## **United States Department of the Interior**

IN REPLY REFER TO: 2015-TA-0039

This letter responds to the plans provided to the Fish and Wildlife Service (Service) on October 3, 2014, relating to the installation of a 50 foot long by 10 foot wide concrete access ramp at the Gulf State Park pavilion which lies within the area covered by Service Incidental Take Permit #TE072831-3 (ITP). We have reviewed the information enclosed and are providing the following comments in accordance with the Endangered Species Act of 1973 (87 Stat. 884, as amended; 16 U.S.C. 1531 et seq.).

Proposed ramp location photo

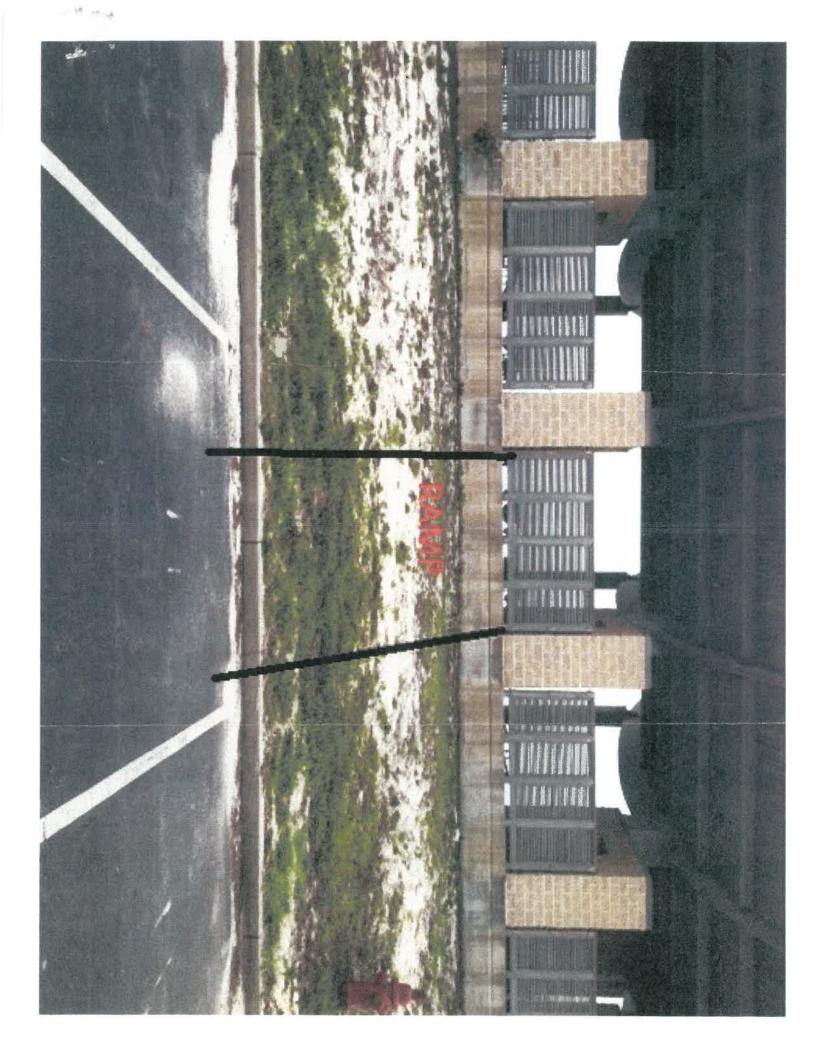
The photo submitted for the proposed concrete access ramp indicates the ramp will be located between the parking lot and the rear of the pavilion (attached). The location will be within the area of "take" specified by the permit for the Alabama beach mouse (ABM) (*Peromyscus polionotus ammobates*). Based on the submitted plans, we have determined that the project is in accordance with the conditions of the permit, and no further endangered species consultation is required for this project.

We recommend the ramp be designed so that ABM can cross under or through, so it does not constitute a "barrier" to ABM movement. Thank you for the opportunity to comment on your project. If you have any questions, please contact Mr. Bill Lynn of my staff at (251) 441-5868.
